City of Portland, Maine - Building or Use Permit Application

Permit No: 10-0613	Issue Date:	CBL: 013 E016001
-----------------------	-------------	---------------------

Location of Construction: 38 Washington Ave	Owner Name: Michelle Anne Kelley	Owner Address: 46 Royal Pine Drive	Phone: 207-415-7507
Business Name:	Contractor Name: Ken Anderson, Builder	Contractor Address: 263 Preble Street South Portland	Phone: 2073188798
Lessee/Buyer's Name	Phone:	Permit Type: Alterations - Dwellings	Zone: B-2B

Proposed Use: Two Family / Renovate ground floor to a one bedroom apartment, also change doors to fire doors in all common areas.	Proposed Project Description: Renovate ground floor to a one bedroom apartment, also change doors to fire doors in all common areas.
---	--

Michelle Kelley
38 Washington Avenue
CBL: 013 E016 001
Basement

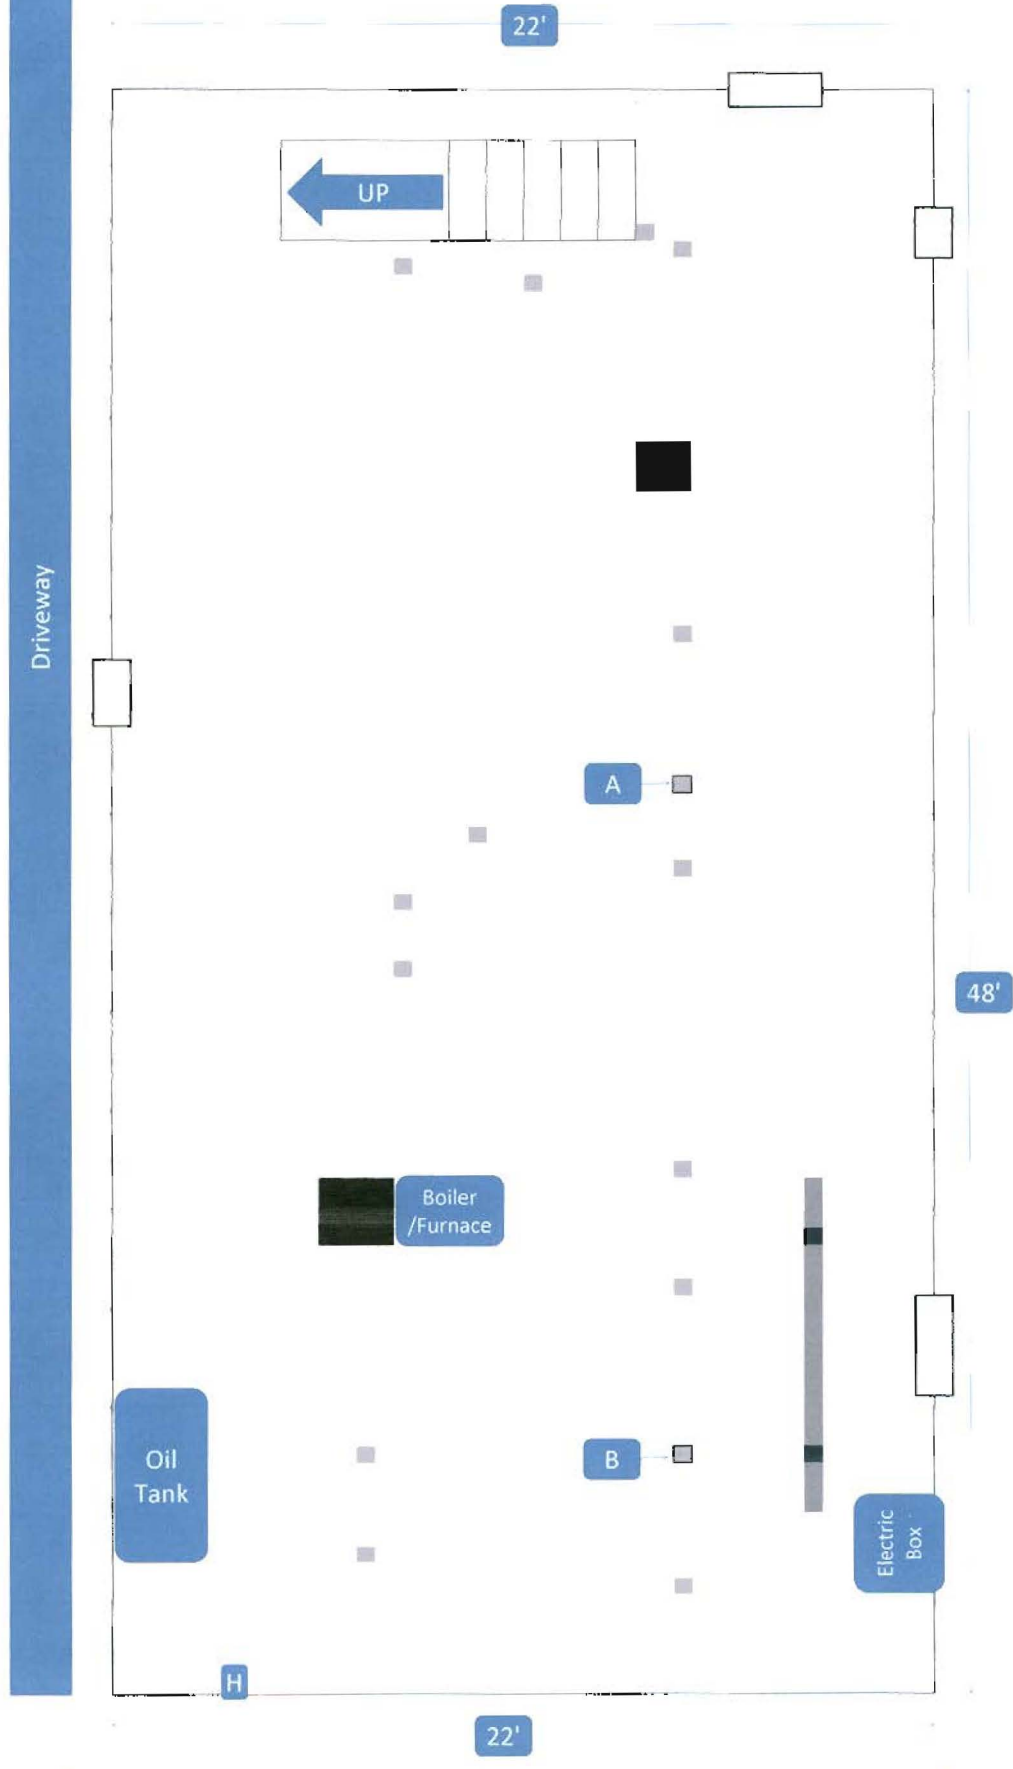
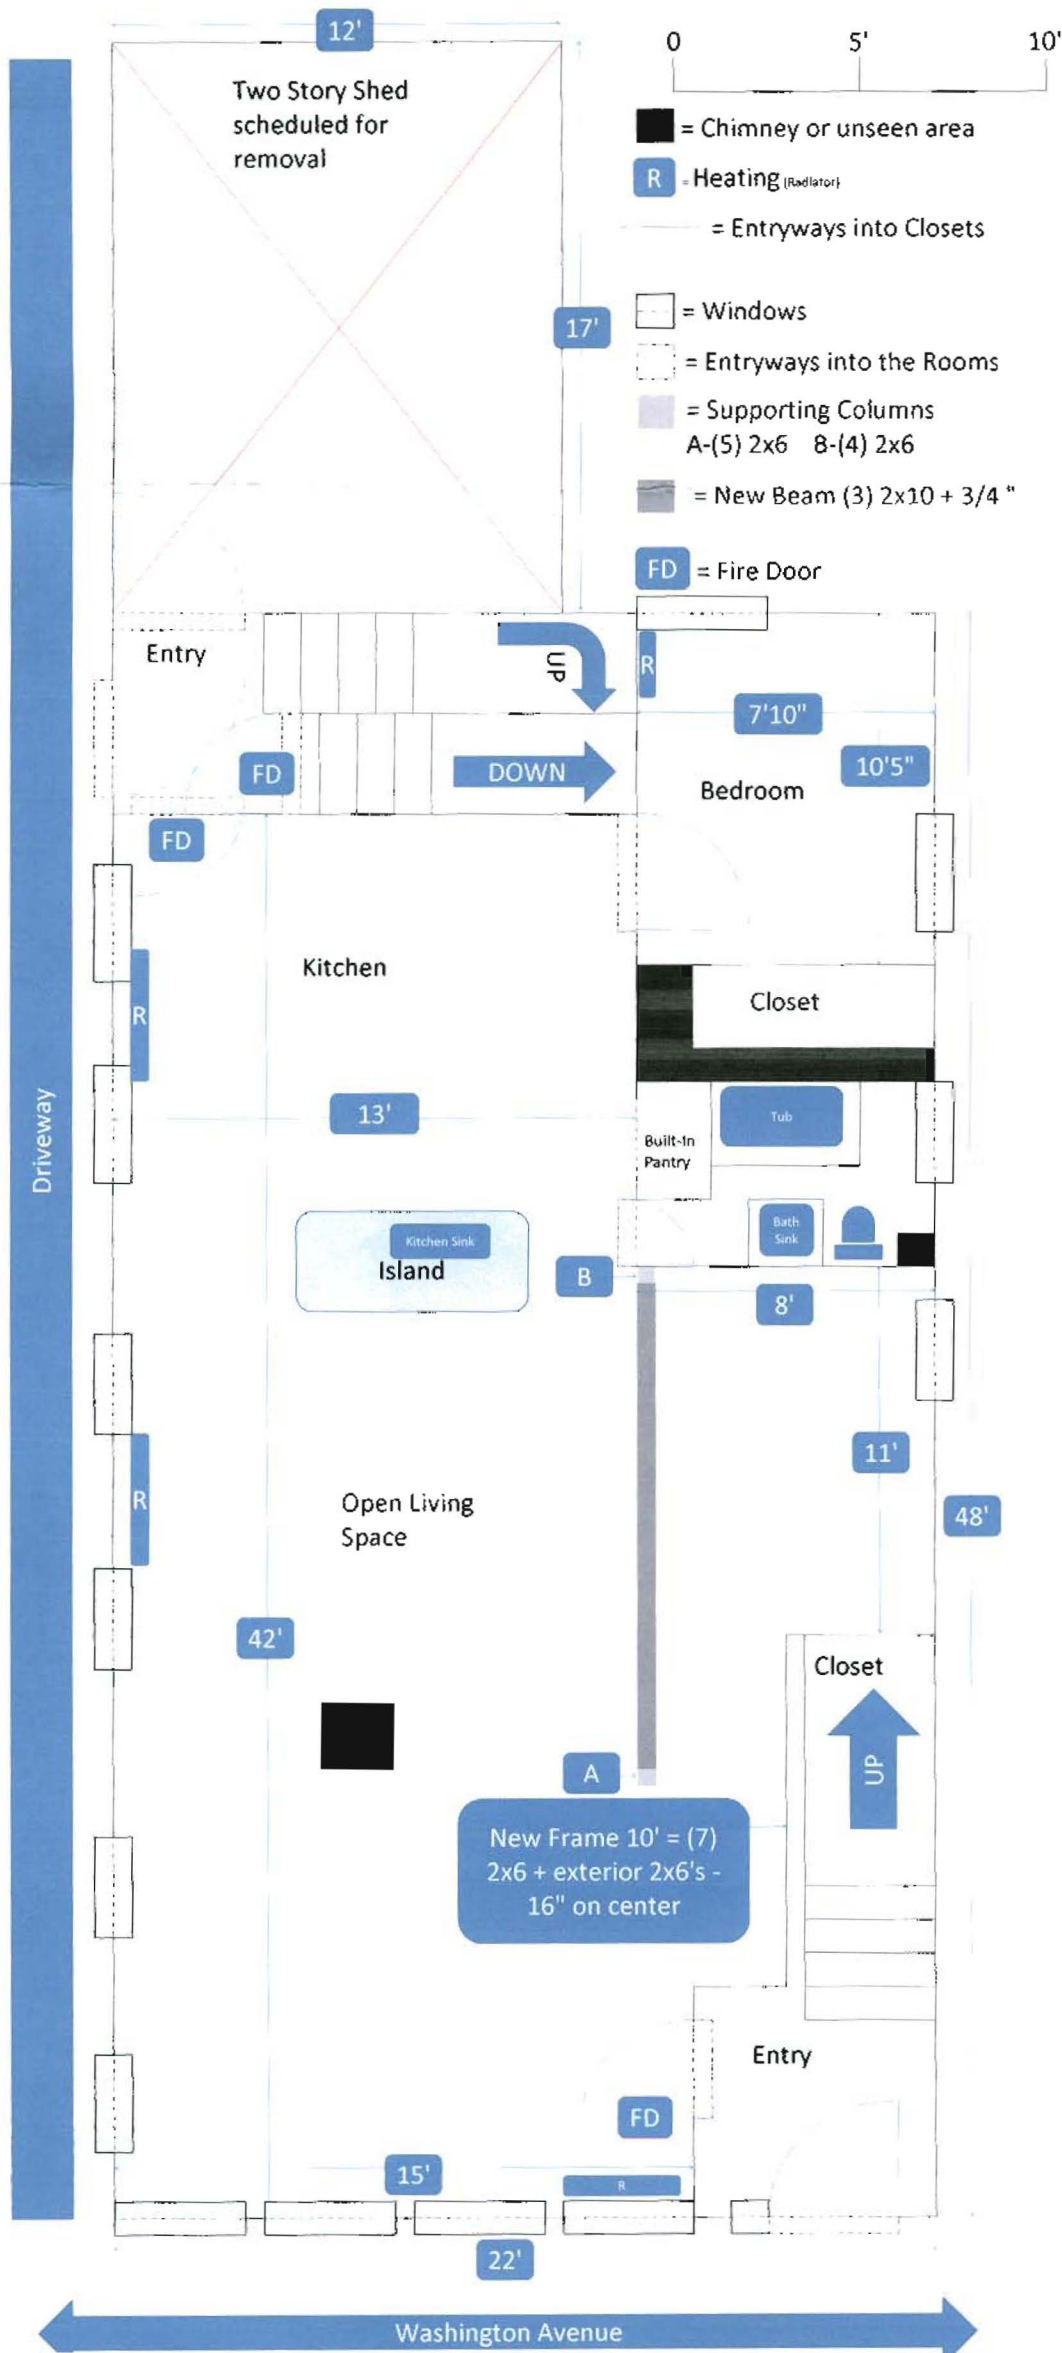
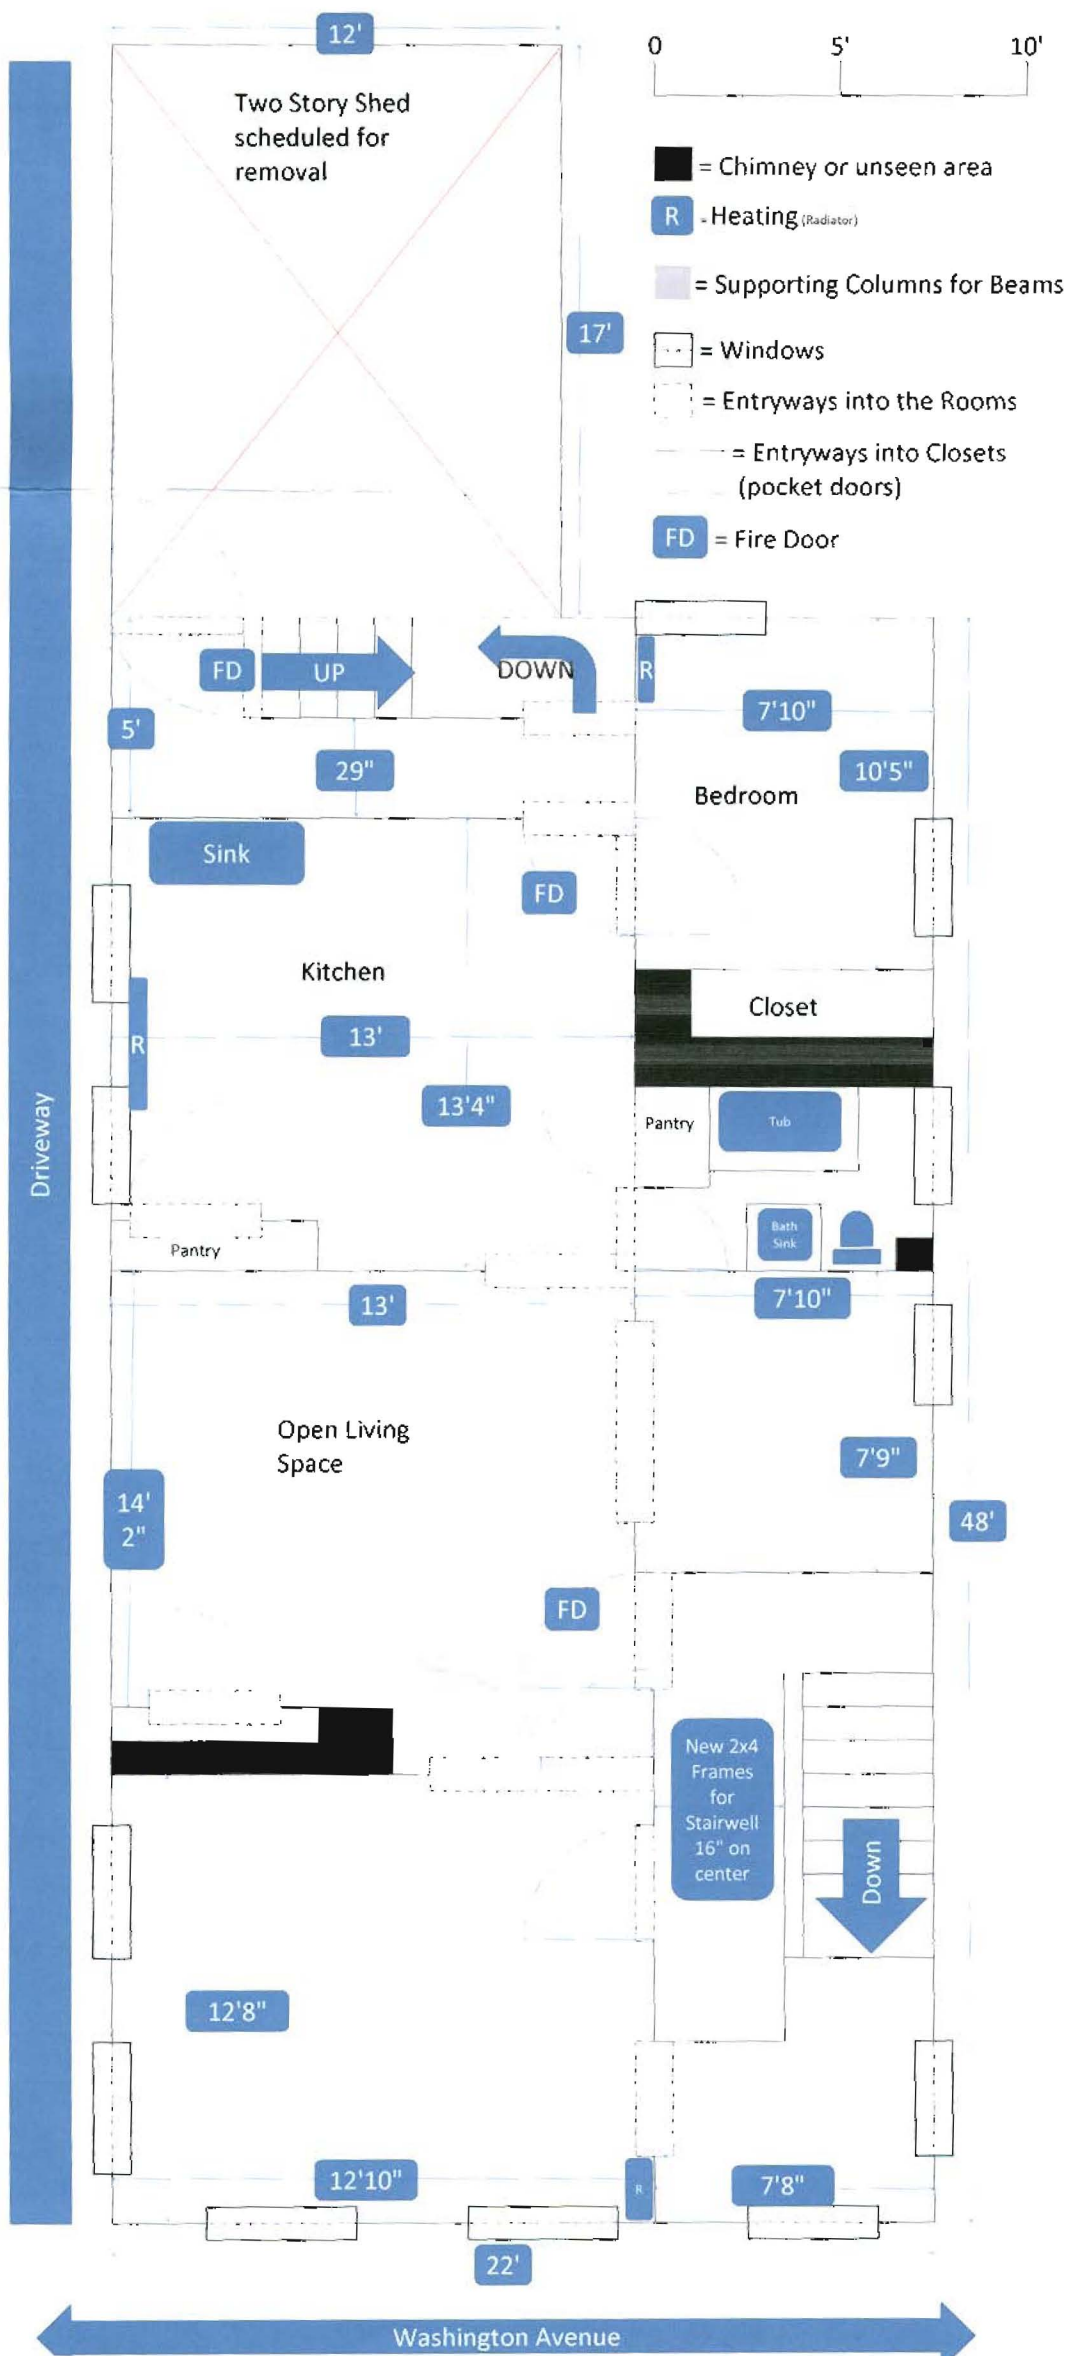
6/22/2010-jmb: Spoke with Ken A. For clarification on the existing floor joists as the narrative and drawings conflicted. Insulation in ceiling of 1st floor with strapping ok. Asbestos siding to remain, siding over, discussed the existing stairs to the 3rd floor, not compliant and there is no gap to allow for sheetrock on the walls. No work is allowed on the 3rd floor or the stairs, except installation of a fire door. Separate permits is required for work on the 3rd floor.

Outcome: Met Michele on site to inspect the existing conditions and for occupancy of the 2nd floor apartment. First floor gutted out and new beam has been installed to carry floor opening for 3rd floor stair, this is also carried into the basement, but there is no sign of new footings. Second floor is in good shape, smokes work, need CO detector. Stair to 3rd floor is not consistent in rise and framing was not held off the wall studs for sheetrock. Third floor has been reconfigured and a hallway was created close to the eave of the rafters so headroom is well below required height. No further work allowed in this area. Furnace needs to be serviced and sewer appears to be exposed at a clean out, no water at this time. Michele will contact when ready for inspection.
